## Technical Note

Project: Ryebank Fields, Chorlton

Title: Layout Update – Highways Aspects

| Swept Path Analysis<br>Substation Access |

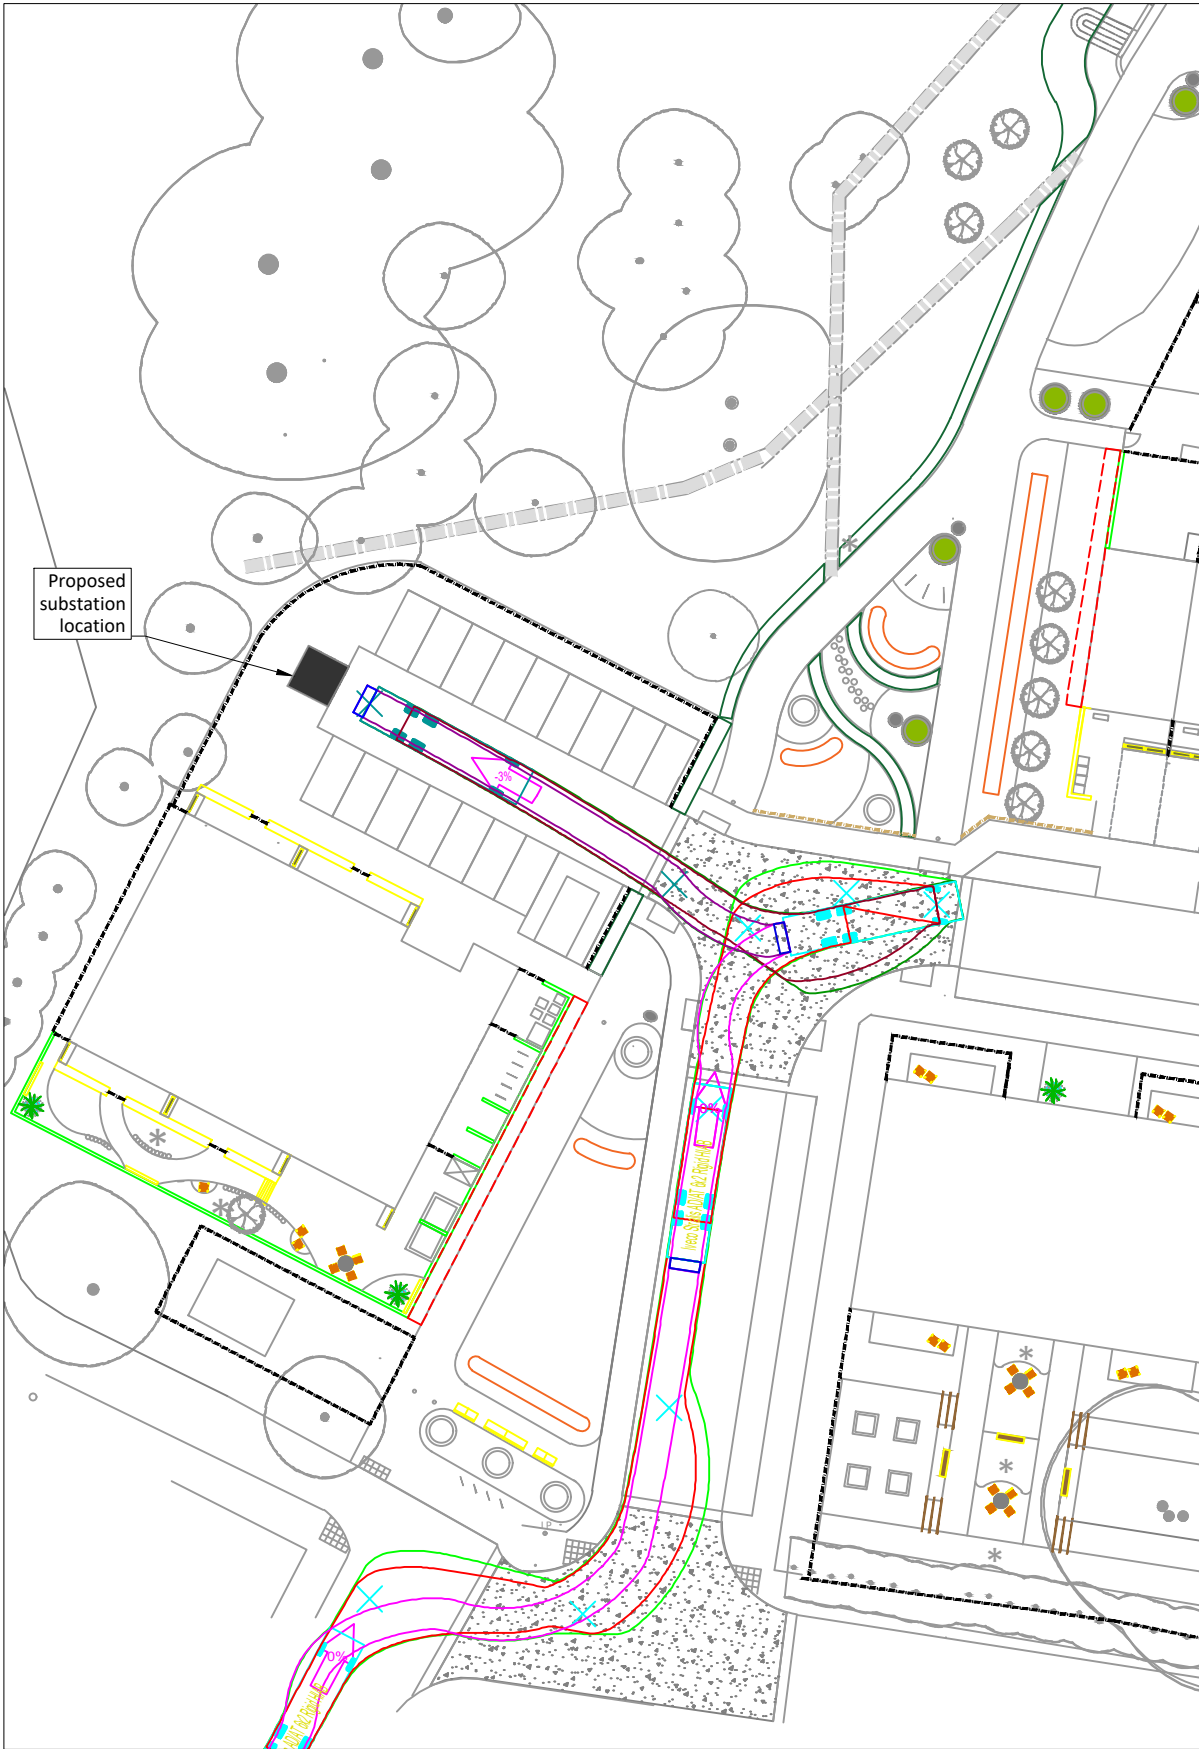
- 2.9 The proposed substation within the site has also been relocated. Occasional maintenance access is typically required for substations, normally only requiring van access. However there may be an occasional requirement for a major component to be replaced and in these circumstances a larger HGV may be required. These would typically require a flat bed truck with HIAB.
- 2.10 Swept path analysis has been undertaken for an 18T rigid truck, to illustrate the access arrangement in the event this size of vehicle requires access. The swept path analysis is shown in Appendix D and shows that the vehicle can comfortably approach the sub-station location.
